To: Jennifer Murray, Windmill Development Corporation
From: Carl Bray, Bray Heritage
Date: Friday, September 8, 2017
RE: 15 Aylmer Avenue/Southminster United Church CHIS/Response to Agency Comments

Response to Agency Comments

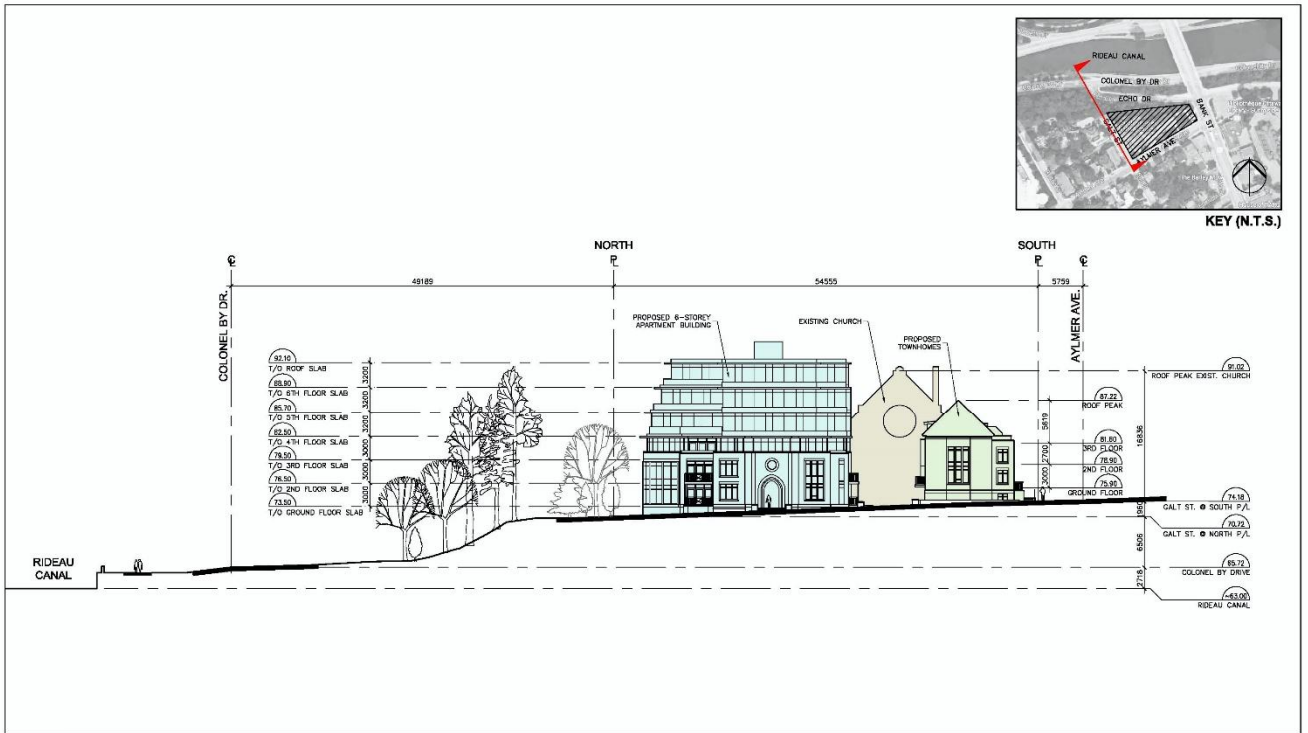
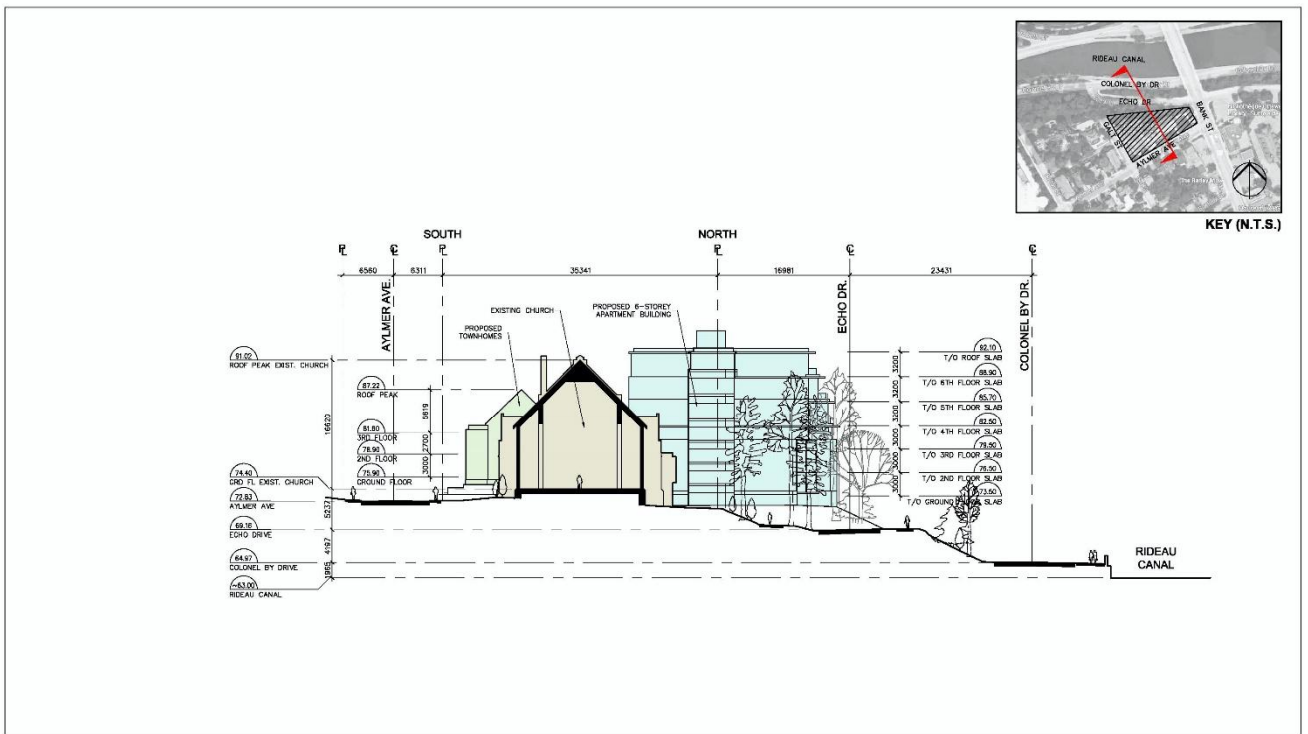
- In the letter of 18 July, 2017, Parks Canada staff requested views of the proposed development from the Canal, specifically asking for renderings of the north façade of the proposed six storey building. Staff also had concerns about the amount of glazing proposed for the building, suggesting that masonry would be more compatible with the existing church.
- In an email of 6 July, 2017, National Capital Commission staff also requested renderings of the north façade and provided mapping showing suggested view locations. Staff also recommended material changes (masonry substituting for glazing, especially in terms of impact on night views of the building), and requested further information on measures for conserving mature trees on NCC lands abutting the development site.

The renderings shown here have been prepared by the project architect, using photographs supplied by the NCC. Each provides an approximation of the view of the church from two key viewpoints along the Canal: from the east, looking towards the bridge and the church façade; and to the south, from the opposite bank of the Canal (this also approximates the view from the Canal navigation channel). In both renderings, the proposed six storey residential building is visible next to the church and slightly above the treetops. The scale relationship is also shown in the two sectional views provided above. The new building is slightly higher than the church but does not extend beyond the rear half of the church. As a result, the church façade and the majority of its massing are clearly evident, especially when viewed from Bank Street, from the bridge, and from the Canal looking west towards the bridge. Views directly south from the Canal have the new building overlapping the rear portion of the church.

In terms of visual impact, the character of views from the Canal of the subject property has not been specified in either Parks Canada or National Capital Commission policies and guidelines. At present, existing views of the church as seen from the Canal have it appearing behind and above a screen of mature trees. In order to reduce the visual impact of the proposed six storey building to be located on the north side of the church, between it and the Canal, both agencies have suggested further mitigation measures that involve height reduction and material changes. Lowering the height of the proposed residential building, while somewhat reducing its visibility from the Canal, would jeopardize the feasibility of the church rehabilitation project and thus has to be weighed against the potential cancellation of a development that has significant community benefits. More applicable mitigation measures here could involve material changes for the building exterior, currently shown as being extensively glazed. By increasing the amount of masonry cladding on the building such that the ratio of wall to window is greater, and the overall colour is darker, the new building will be able to blend more easily with the tree canopy and with the stone exterior of the church. Conserving the mature trees on NCC property will retain the existing tree screen.

- Increasing the amount of masonry cladding on the exterior of the proposed six storey building
- As part of the final submission, providing revised renderings showing these changes
- Working with the NCC to conserve the mature trees that are adjacent to the development site
